COUNCIL REPORT

File No: DP 20-18

Subject: **DP 20-18, Development Permit with Variance, 657 Westside Road**

Figure 1 - Proposed Development at 657 Westside Road

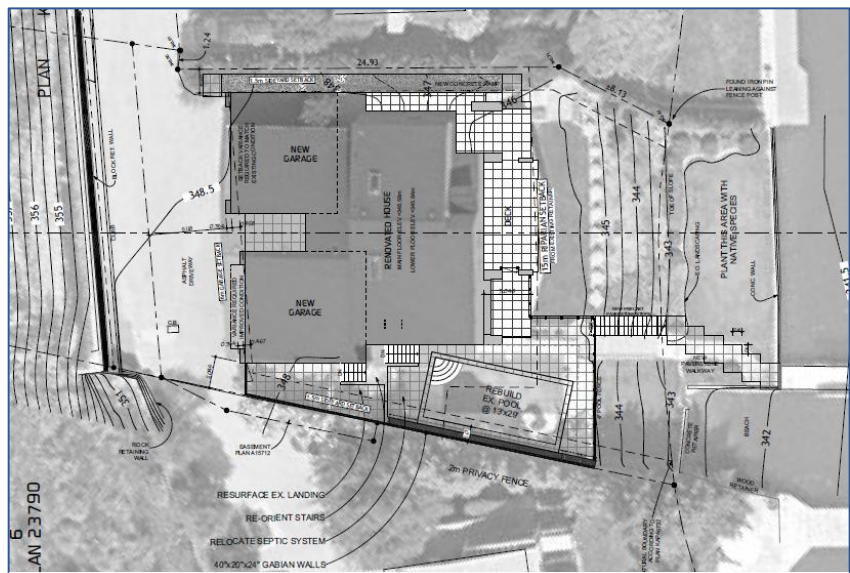
A Variance request has been included in the application to reduce the required setback from a private access easement from 6.0 m required to 5.47 m proposed for the attached garages. The proposed variance would be a reduction from the current encroachment of the existing garage and is not anticipated to create significant negative impacts to surrounding property owners.

Figure 3 - Proposed Restoration Plan

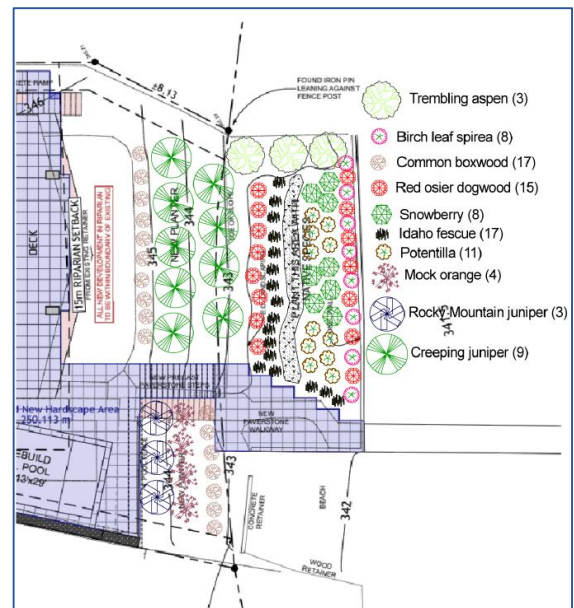
The landscape plan included within the EIA is robust and includes the addition of 92 shrubs and 3 trees within the SPEA (Figure 3). The proposed restoration area provides compensation for the historical development areas within the SPEA and is intended to

act as a bank stabilization along the slope between the pool deck and the lower dock area.

In addition, the restoration area will provide on-site stormwater management through a rock pit distribution system. The EIA does not anticipate the dispersion of rain and melt water to cause any negative impact to the riparian area. A cost estimate for plantings, installation, irrigation and monitoring has been provided for a total of \$3950.00, which has been used to calculate the performance security of \$4937.50 (125%) that is required as a condition of the Aquatic Development Permit.

Figure 4 - Failing Retaining Wall

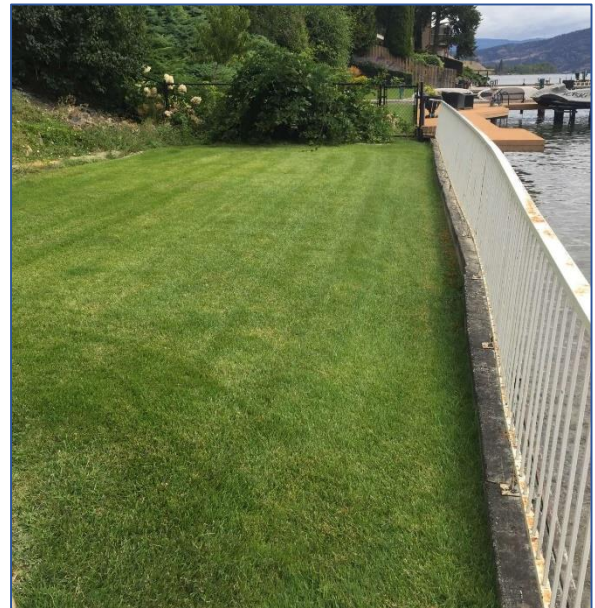
The applicant has also submitted a Section 11 *Water Sustainability Act* Notification Application for proposed repair/replacement of a failing retaining wall at the highwater mark of Okanagan Lake. The applicant will advise the City of the outcome of this application to the Province.

This application was referred to the Okanagan Basin Water Board for comment who advised that based on the OBWB's flood map website (OkanaganFloodStory.ca) the site could be subject to some wave damage under high water conditions.
